MECKLENBURG COUNTY
DEPARTMENT OF ENVIRONMENTAL HEALTH

APPLICATION FOR SOIL INVESTIGATION

APPENDIX H
SITE EVALUATION

SITE INVESTIGATION REPORT
INDIVIDUAL SEPTIC TANK SYSTEM WITH SUBSURFACE, SOIL ABSORPTION, EFFLUENT DISCHARGE

* See Diagram on Back (Include: Soil areas, property lines, roads, streams, gullies, wet areas, fill areas, wells, water bodies, slope patterns)

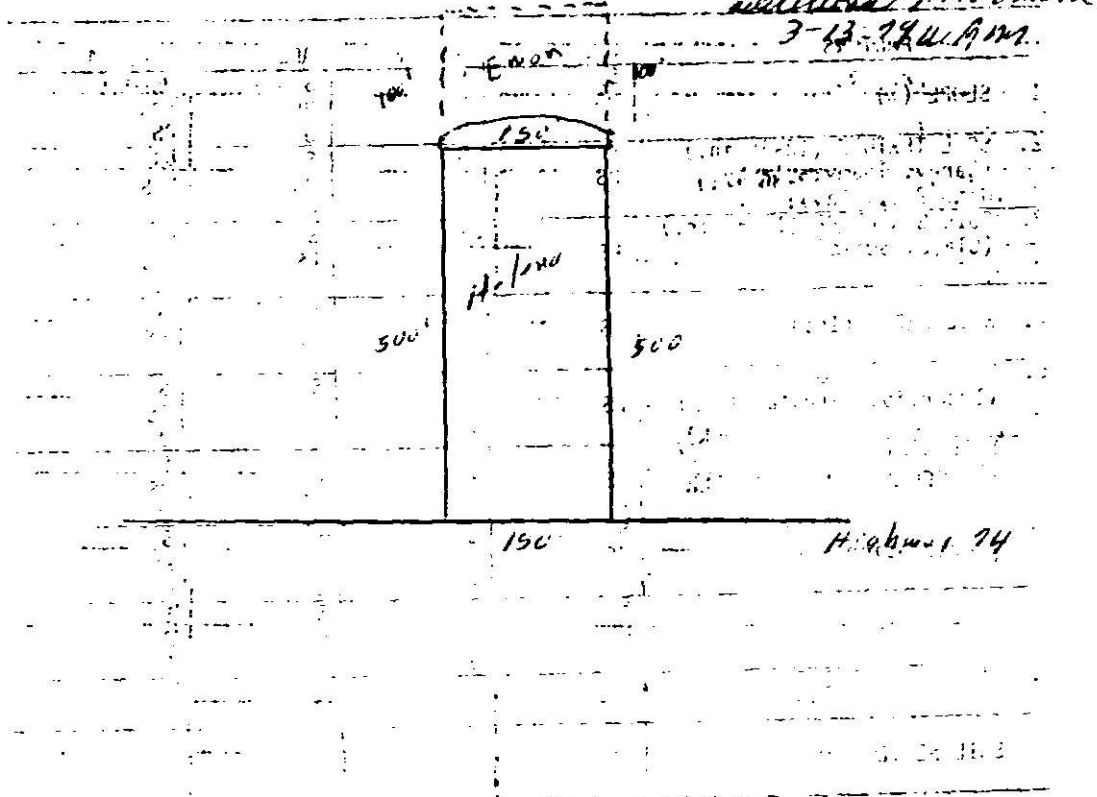
FACTORS	AREA 1	AREA 2	AREA 3	AREA 4
1. SLOPE (%)	~~S~~ PS 2-6% U	S PS U	S PS U	S PS U
2. SOIL TEXTURE (12-36 in.) (Sandy, loamy, clayey, Note 2:1, Clay)	S L-1 PS ~~U~~ Clay	S PS U	S PS U	S PS U
3. SOIL STRUCTURE (12-36 in.) (Clayey Soils) ✔	S Massive PS ~~U~~	S PS U	S PS U	S PS U
4. SOIL DEPTH (In.)	~~S~~ 48" PS U	S PS U	S PS U	S PS U
5. RESTRICTIVE HORIZONS (In.) (Impervious Strata, Rock)	S None PS U	S PS U	S PS U	S PS U
6. SOIL DRAINAGE/GROUNDWATER (External & Internal) ✔	S Seasonal PS Perched U ~~water Table~~	S PS U	S PS U	S PS U
7. SOIL PERMEABILITY (Percolation Rate) ✔	S PS 0 Slow U	S PS U	S PS U	S PS U
8. OTHER (Specify)	S PS U	S PS U	S PS U	S PS U
9. SITE CLASSIFICATION ✔	Acceptable			
SOIL SERIES	Helena

Additional Area Needed
3-13-94 Mtg.
150'
500'
500'
150'
Highway 74
